Device Errata

Skywire™ Modem

NimbeLink // Products
Published // June, 2015

5 Board Rework

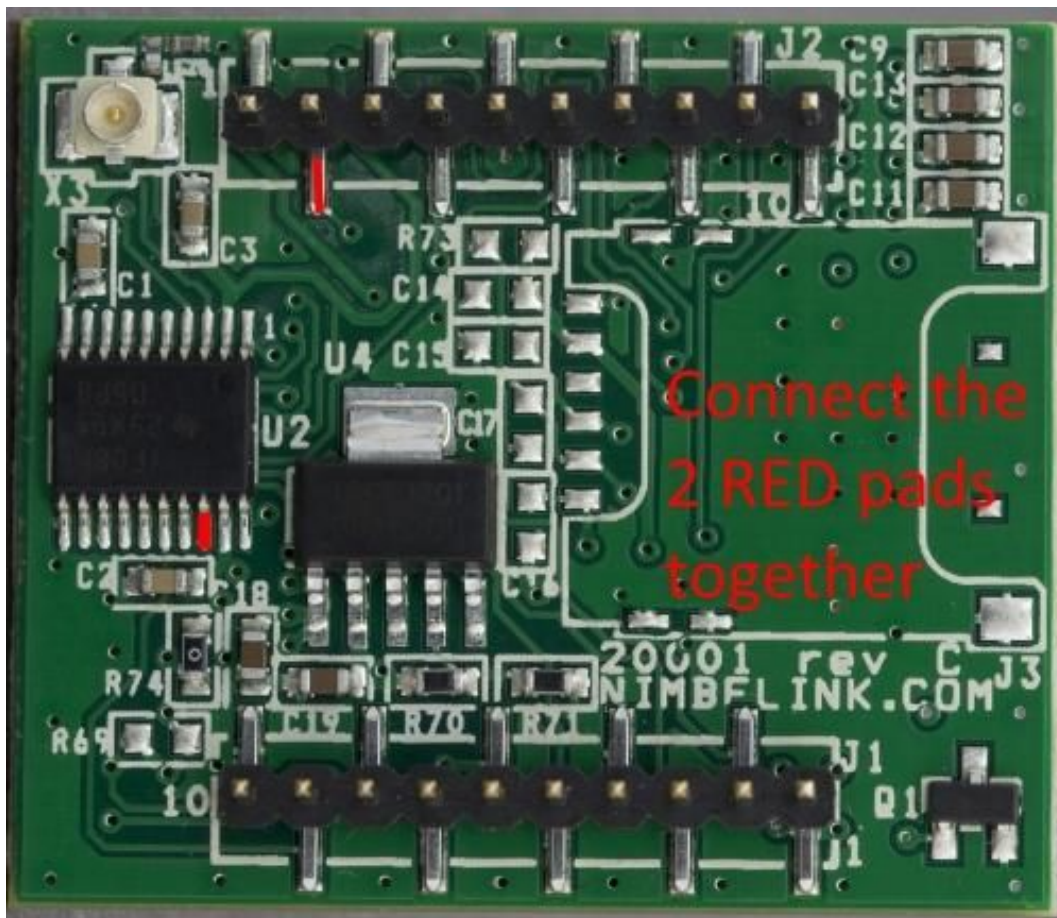
This Errata affects applications requiring use of the UART CTS hardware flow control output from the Skywire™ modem. The UART CTS signal (Pin 12 on the XBEE interface) is not connected on NimbeLink PCBs prior to PCB revision F. This Errata does not affect your design if any of the following are true:

The Errata can be repaired on affected product by soldering a wire to the underside of the modem. The wire must connect XBEE interface pin 12 to U2 pin 18. Adding this wire will not invalidate the product warranty, however, poor workmanship can damage the modem and invalidate the warranty.
